TORRINGTON PLACE SUBDIVISION

APPLICATION NUMBER 20 DATE June 7, 2007

DETAIL SITE PLAN

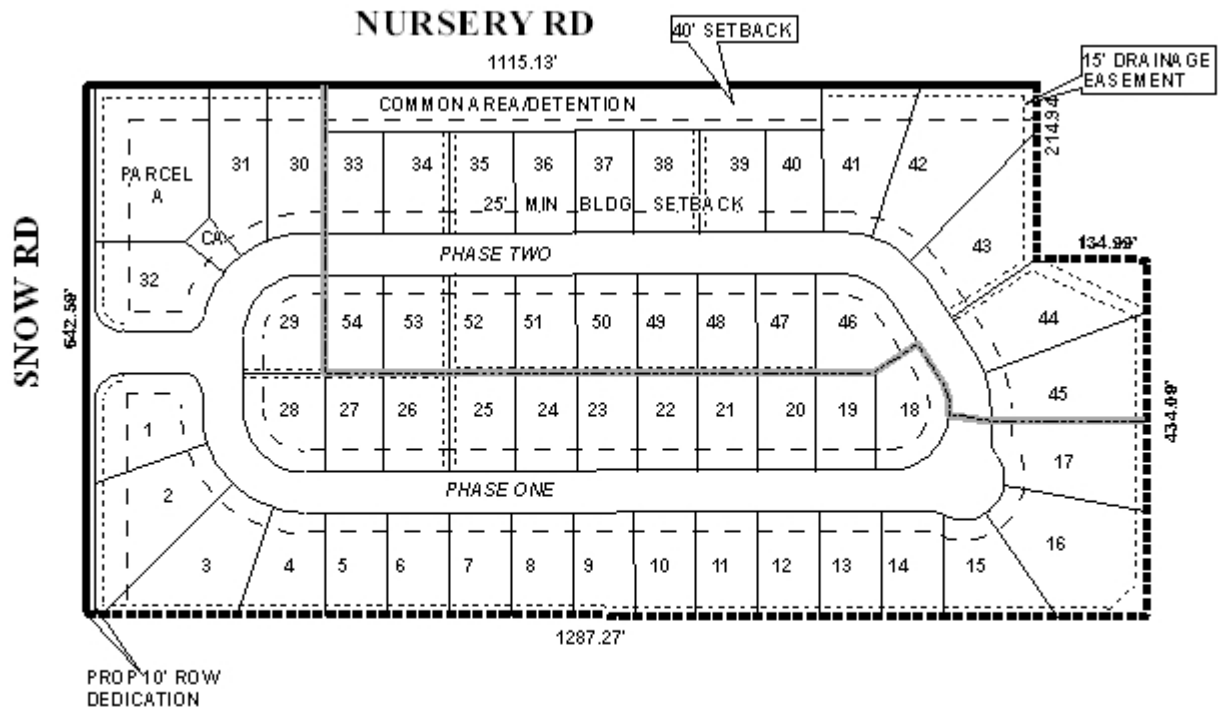
The purpose of this application is to subdivide two parcels into 55 lots. The detention area for the development has been changed so that it is located parallel to and abutting Nursery Road, separating Lots 33 to 40 from Nursery Road. A common area has also been reduced in size compared to previous applications. Finally, the plat indicates that the site will be developed in two (2) phases: the detention area is shown in Phase Two, however, the applicant should ensure that the detention area be functional prior to the completion of Phase One.

The site fronts onto Snow Road, a proposed major street, and Nursery Road, a minor street. Snow Road should have a right-of-way width of 100 feet instead of the existing 80 feet, and the preliminary plat depicts dedication of an additional 10-feet to Mobile County. Nursery Road has an adequate right-of-way, however, the preliminary plat indicates that the right-of-way is 80 feet, while GIS data indicates the right-of-way may be 60 feet in width: the width should be verified with County Engineering and the plat revised if necessary.

Access management is a concern for the site. The main portion of the subdivision will have access to Snow Road via internal streets, however, some lots will have double frontage. A note should be placed on the plat stating that all lots and the detention area, with the exception of "parcel A," are denied direct access to Nursery Road and Snow Road North. The proposed "parcel A" should be renamed to "Lot 55" or "Lot A," and should be limited to one curb-cut onto Snow Road and one curb-cut onto Nursery Road. The size, design and location of all curb-cuts should be approved by the Mobile County Engineering Department. It should also be noted that the detention area located on the North side of the site will only have frontage onto Nursery Road.

A detention basin and common area are proposed for the subdivision. The detention basin should be labeled as a common area and all common areas should be identified. A note should also be placed on the final plat, if approved, stating that maintenance of the common areas is the responsibility of the subdivision's property owners.

- 1) verification of the right-of-way width for Nursery Road, and correction of the plat if necessary;
- 2) the dedication of right-of-way sufficient to provide 50-feet from the centerline of Snow Road, as depicted on the preliminary plat;

- 3) the renaming of "parcel A" to "Lot 55" or "Lot A";
- 4) placement of a note on the final plat stating that all lots and the main detention area, with the exception of Lot 55 (or Lot A), are denied direct access to Nursery Road and Snow Road North, that Lot 55 (or Lot A) is limited to one curb-cut onto Snow Road North and one curb-cut onto Nursery Road, and that the size, design and location of all curb-cuts are to be approved by the Mobile County Engineering Department;

- 5) labeling all common areas, including the detention basin, and placement of a note on the final plat stating that maintenance of the common areas is the responsibility of the subdivision's property owners;

- 7) keeping the lot size information depicted on the preliminary plat on the final plat; and
- 8) placement of a note on the final plat stating that a buffer, in compliance with Section V.A.7. shall be provided where the commercial properties adjoin residential property.
